Product Change Notice (PCN)

PCN Number: 0454699R-01

Product(s) Affected: *UJ2-BH-1-TH, UJ2-BH-2-TH, UJ2-BH-4-TH, UJ2-BH-W1-TH, UJ2-BH-W2-TH, UJ2-BH-W4-TH, UJ2-BH-BL1-TH*

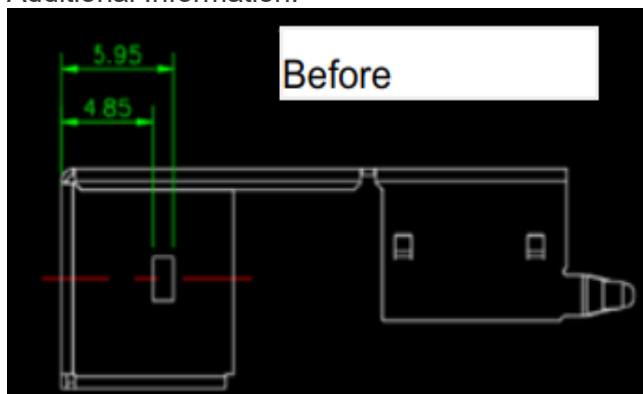
Reason(s) for Change: *Mold Tooling modification for metal shell. Improved mechanical fit.*

Description of Change: *Both plastic housing and metal shell dimensions remain within original product tolerances but contain improvements to enhance structural integrity and achieve tighter fit between plastic housing locking features and the metal shell latch hole. The latch hole has shifted 0.1 mm towards the mating surface. Minimum insertion/pull force has changed from 10 N to 7 N.*
